**From:** [lorijkaylor@gmail.com](mailto:lorijkaylor@gmail.com)  
**To:** [Planning Mailbox](#)  
**Subject:** LU 2021-023 sub cedar creek gardens  
**Date:** Thursday, June 30, 2022 12:06:01 PM

**From:** [dave.sweeney](#)  
**To:** [Eric Rutledge](#)  
**Subject:** Red Fern trees application info...  
**Date:** Tuesday, July 5, 2022 6:21:03 PM  
**Attachments:** [We sent you safe versions of your files.msg](#)  
[Trees recommended for removal in the flagpole section .pdf](#)

## Trees recommended for removal in flagpole that *Should NOT* be removed

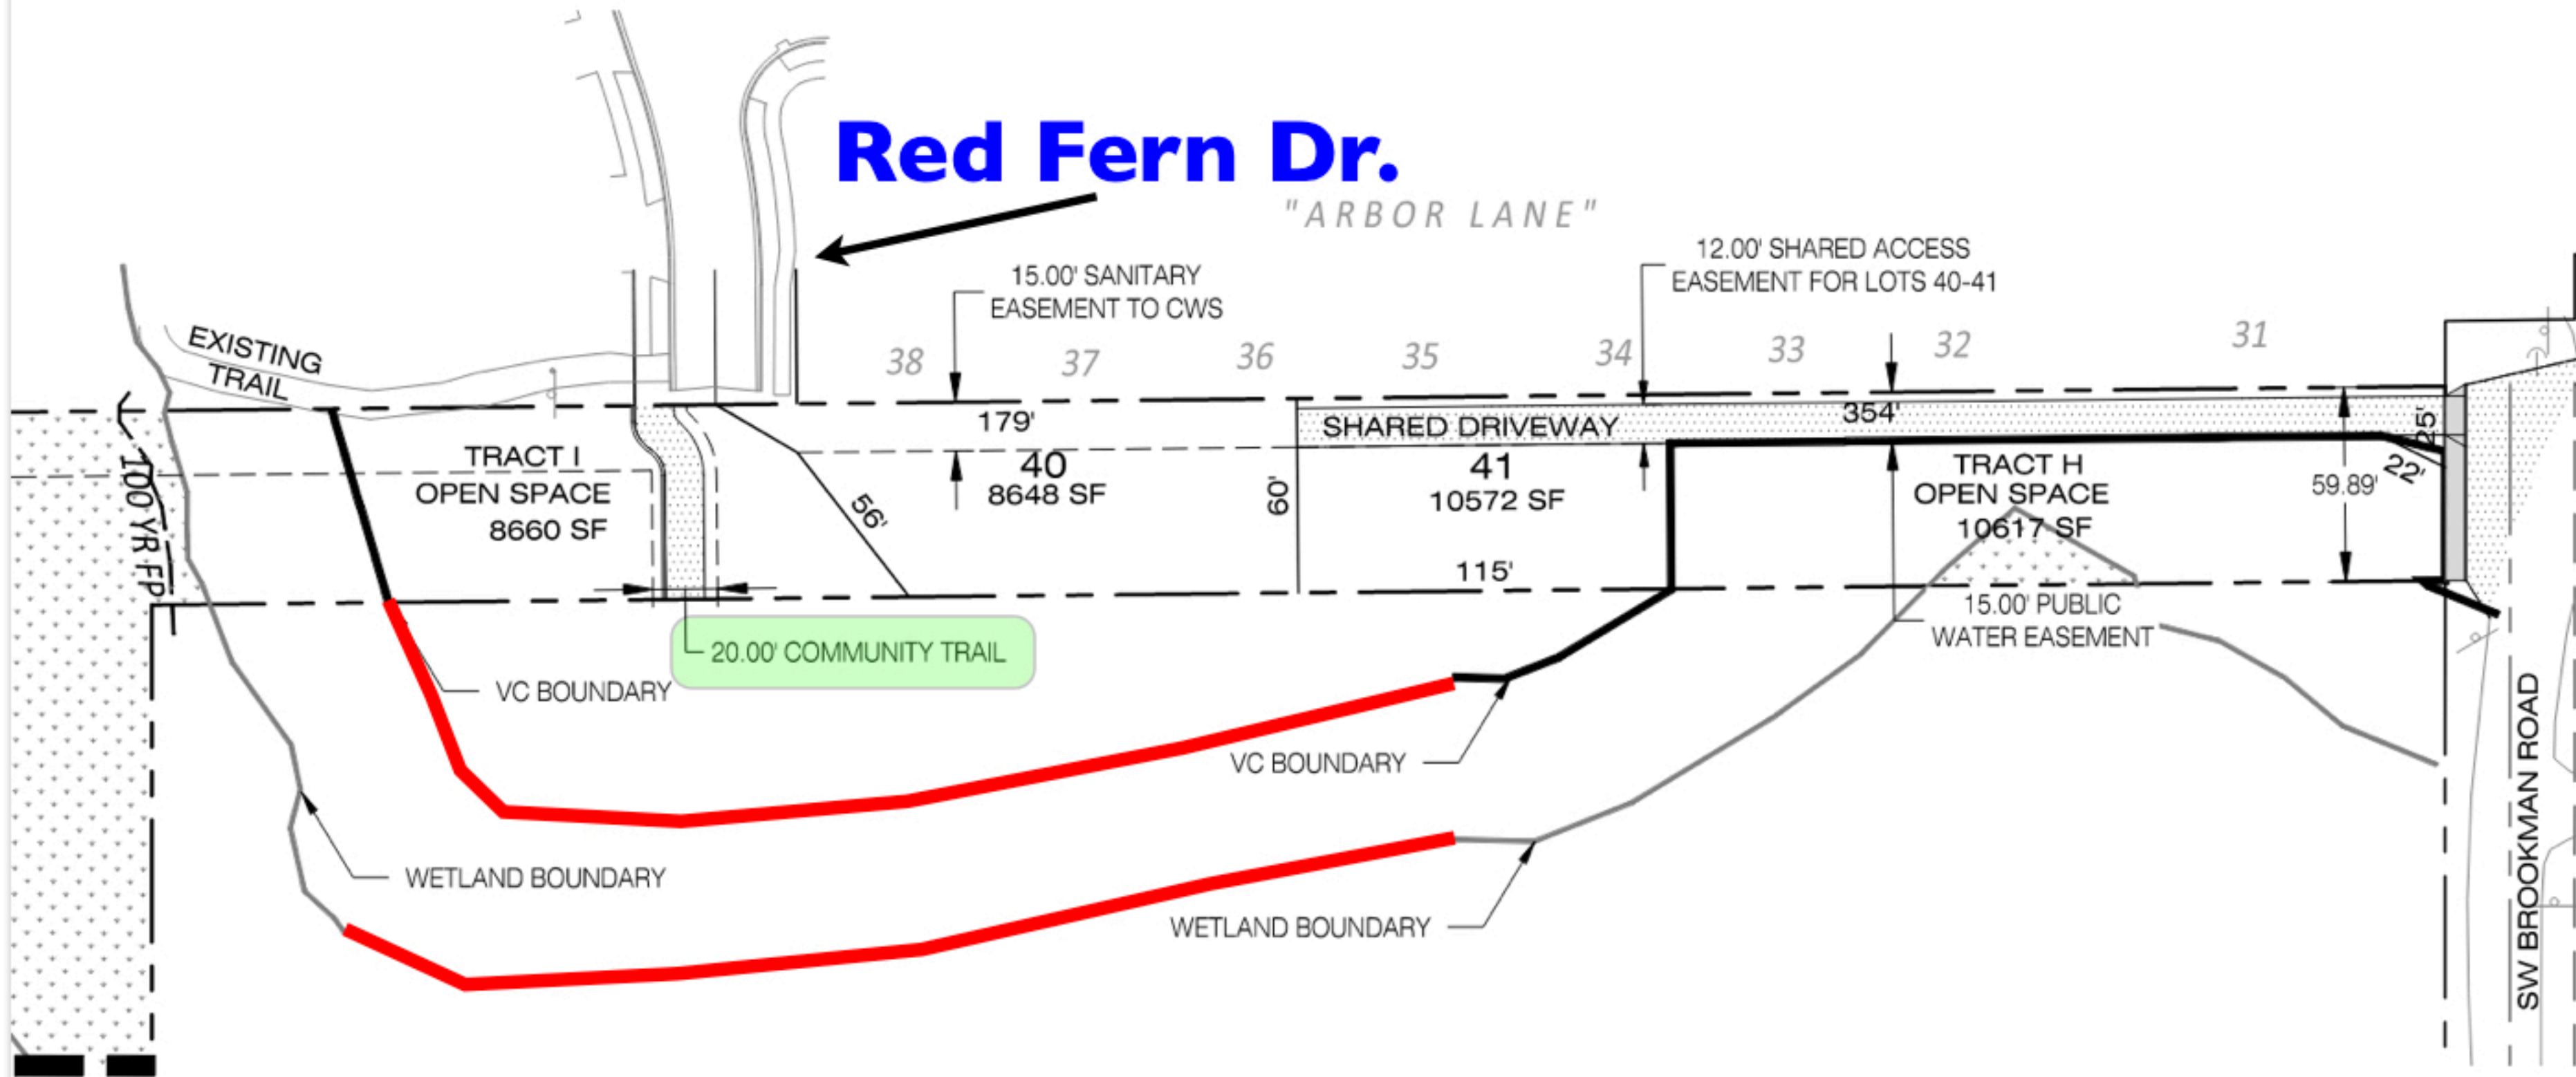
**-Fourth and most important**, extending the "flagpole" trail another 60-80' (south) would run it smack dab into the vegetative corridor (VC) and wetland boundaries. And THAT would

prohibit any further extension of the trail. The developer would end up destroying a section of useable forest open space for the sake of 720 (UNuseable) square feet of asphalt. Quite literally, a trail to nowhere with nowhere to go. (see graphic #1).

**Figure 16F**  
**TRAIL STANDARDS**  
**SHERWOOD**  
**CROSS SECTIONS**

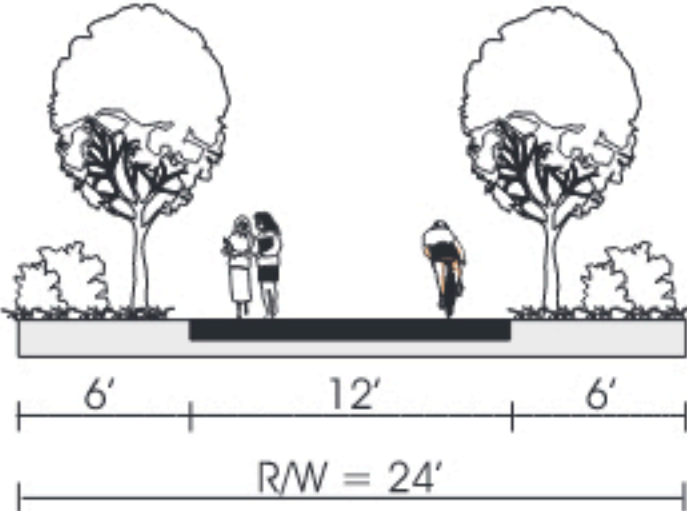
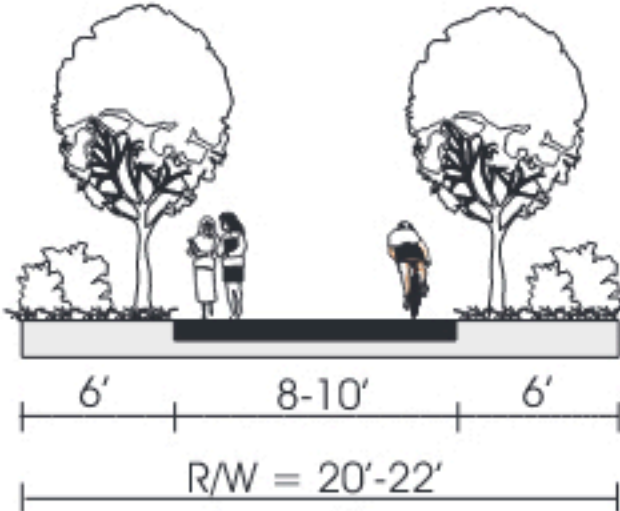
In the 2014 Sherwood Transportation System Plan, page 55, Figure 16F, it shows that the “Feeder Trails” in Sherwood are to be 8-10 feet wide while the “Primary Trails are to be 12’ wide. (See graphic #2).

And here’s the rub...all of the trails in Cedar Creek Gardens are 12 feet wide.

There’s no way any trail serving 39 houses should be considered a “Primary” trail. They are (most obviously) Feeder Trails and should be 8-10 feet wide as are the vast majority of neighborhood trails in Sherwood.

Having 12’ wide trails in the Cedar Creek Gardens subdivision is simply wrong!  
It’s a violation of the Sherwood Trail Standards and should not be allowed to happen!

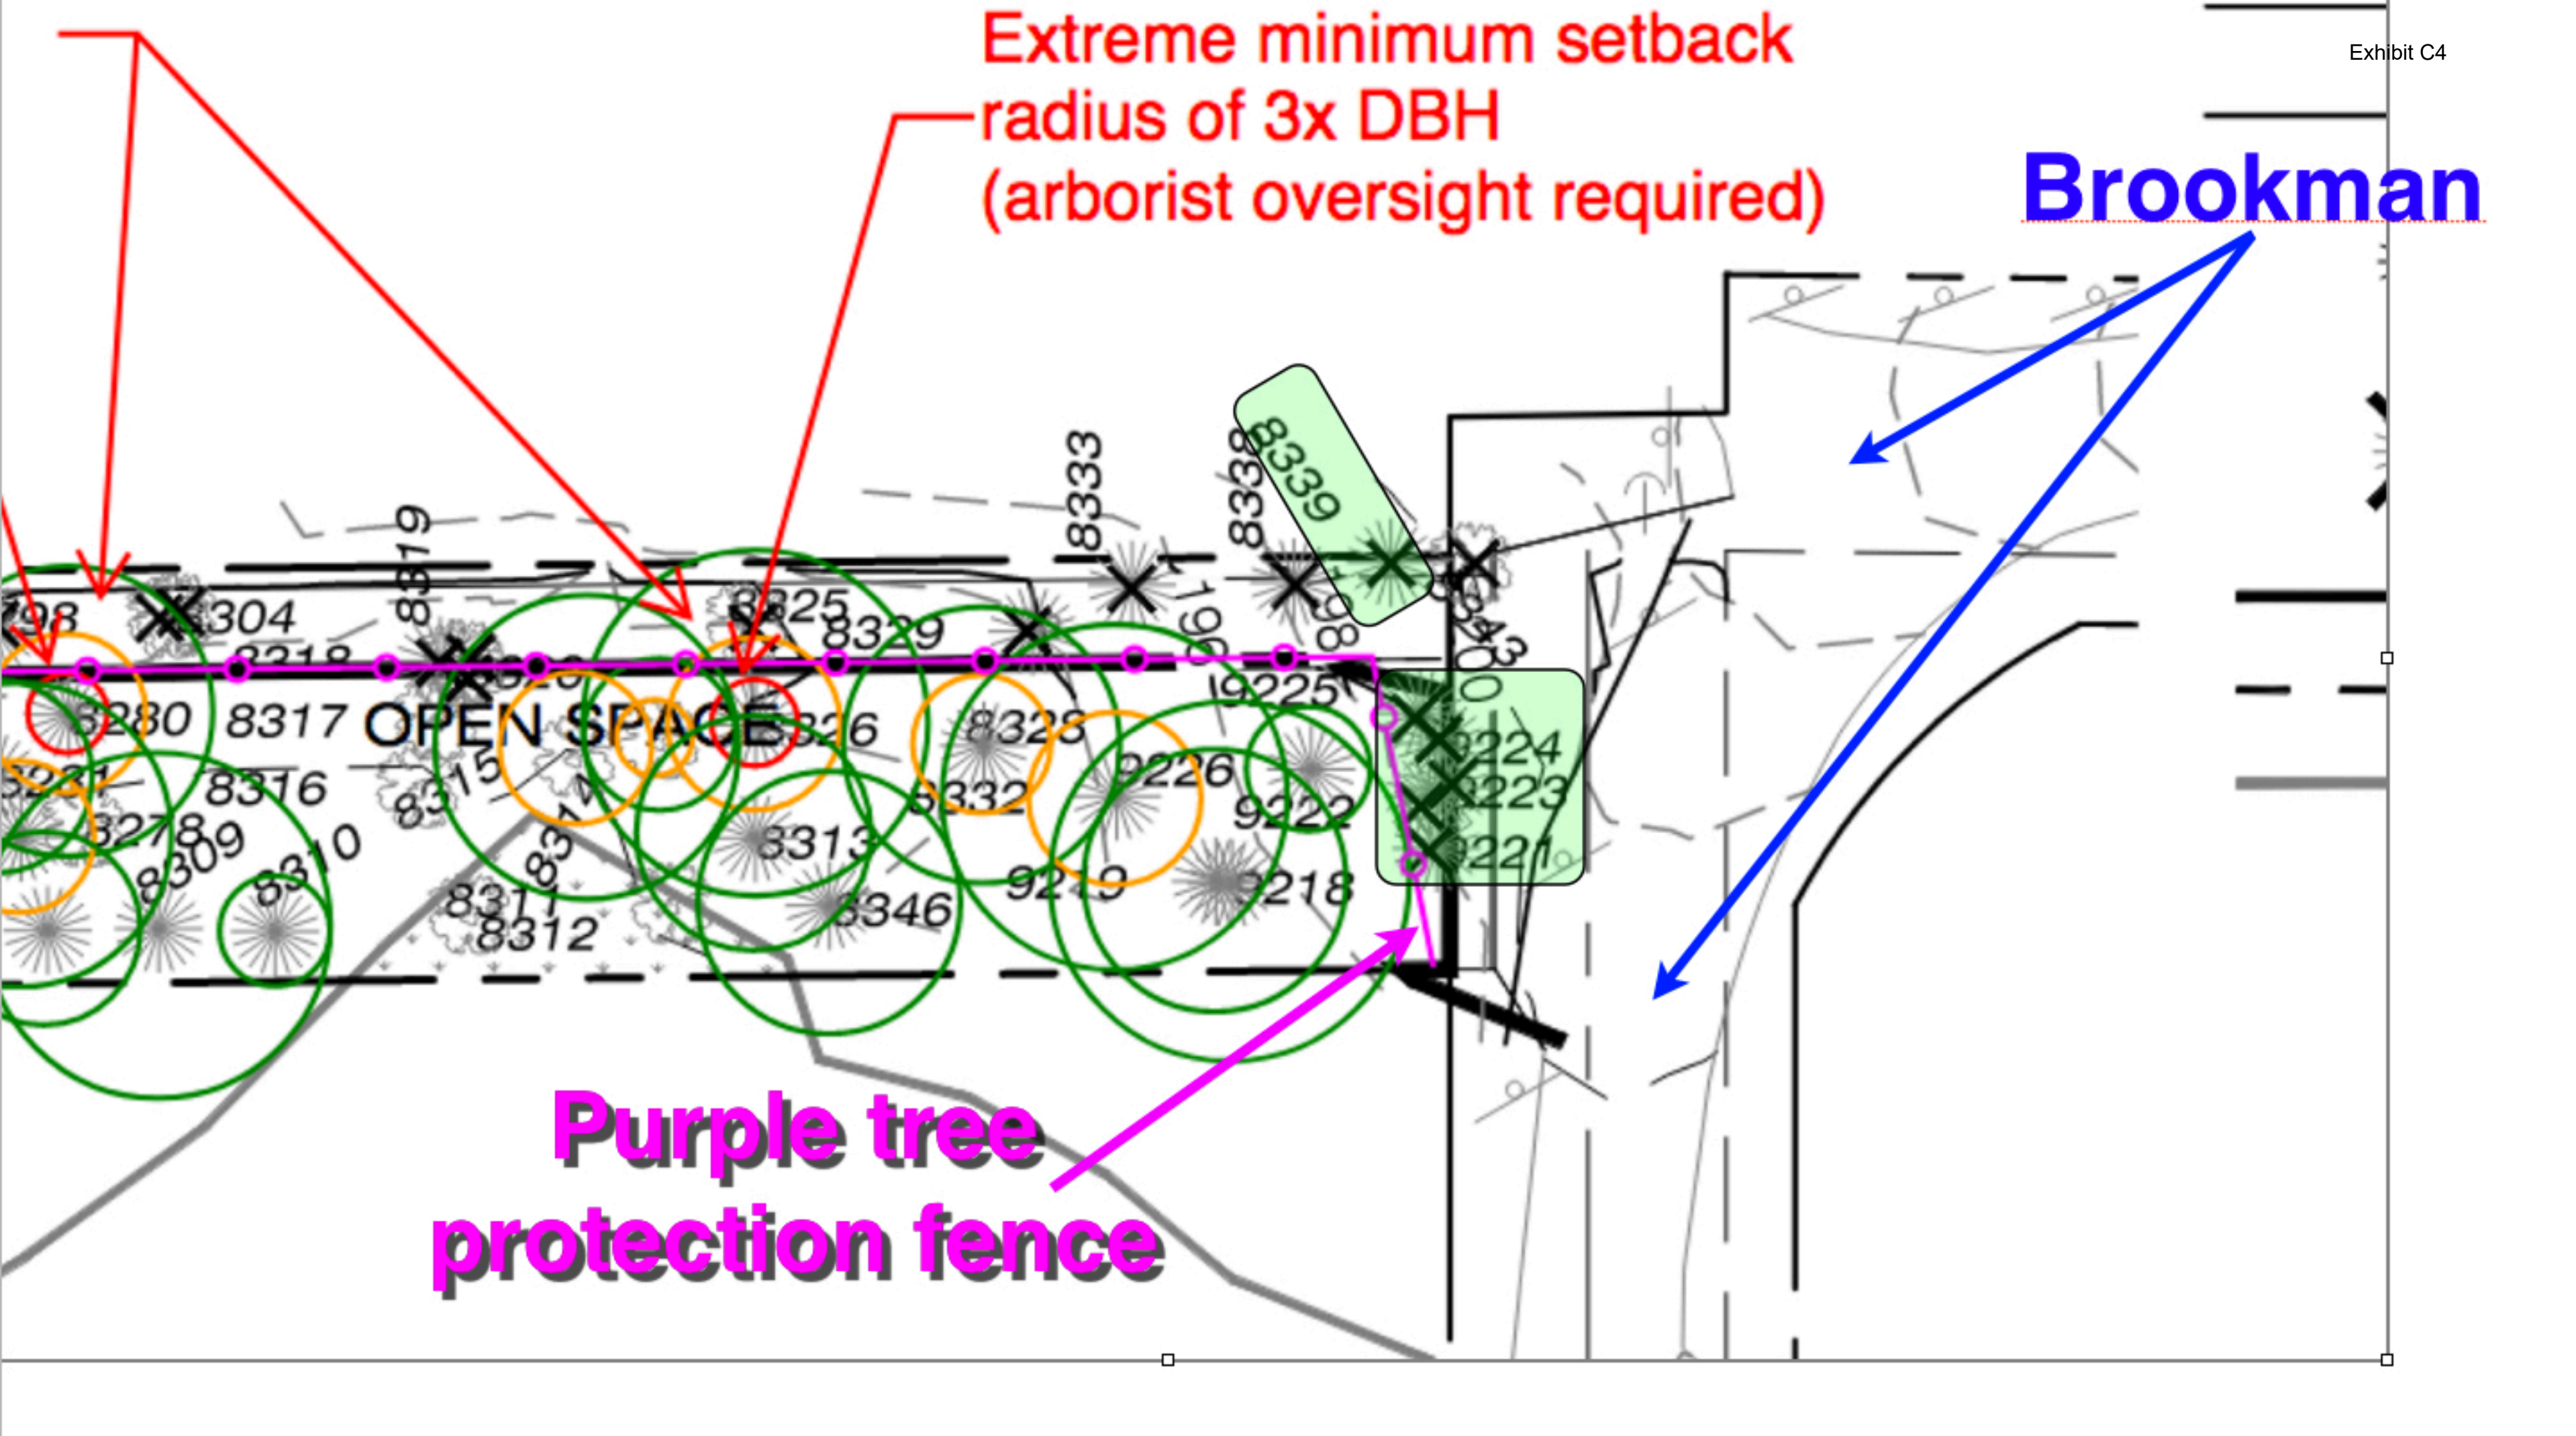
In summary here, all of the Red Fern trees in the light green box (graphic #4) should be retained with the exception of #6586, an 8” DBH Doug Fir that is dead.

The two large, Dougs at the top left corner of that green box (#6602 & 6603) are to the left of the purple tree protection fence and should be protected as all the other trees to the left of that tree protection fence are. There’s no reason to remove those trees. The developer doesn’t need those trees, he’s got 702 trees scheduled for removal. Leaving a few scraps for the peasants won’t hurt him in the least. As for the trees in that graphic to the right of the tree protection fence, although there are several quite large Dougs, most of those are trees are relatively insignificant to the developer. He’s not gonna miss those either but they do enhance the open space to the left of the fence. Why remove them? Don’t strip the area. and lastly, tree #6560 is a very large Doug that is just inside the boundary of lot #40. Again, no reason to

As for the Brookman side trees, those five trees in the light green box are clearly in the open space, Vegetative Corridor area and the purple tree protection fence has been adjusted to exclude those trees from protection. Come on, seriously, he's gonna chop those five down? He's taking close to 700 other trees, he doesn't need those! Plus, they're in the damn protection zone.
